**SERVICE BULLETIN SB FSG2T-1.05**

**TYPE DESIGNATION** FSG 2T VHF/AM Airband Transceiver – Part number F10350

**DESCRIPTION** Verify reliable communication in the vicinity of external RF transmitters, which could disturb active communication channels. Improvement against external RF signal, exceeding the maximum limits, can be achieved by modifying the resistor R1099 and to introduce the capacitor C1207 on the TX/RX module.

Fig. 1: TX/RX Module before modification

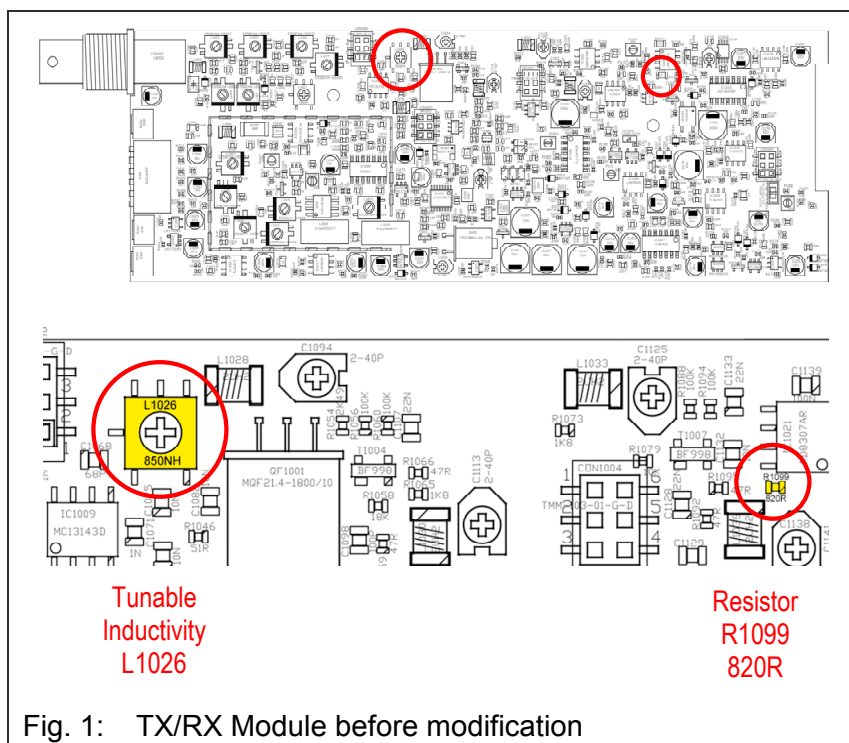
Locate the resistor R1099 (820R) and the tunable inductivity L1026 on the TX/RX Module.

Repair: Replacing the Resistor R1099/820R by a Resistor R1099/150R:

- Use an adequate solder tip to unsolder the 820R Resistor.
- Clean the soldering pads.
- Take the supplied NEW Resistor R1099, 150R, and position it.
- Use an adequate solder tip and solder.

Fig. 3: Position of Mod-Index Label

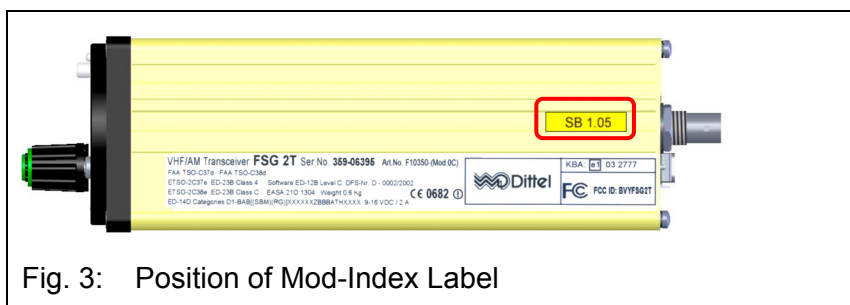
After meeting the required minimum performance values mark the transceiver FSG 2T with the supplied Mod-Index label
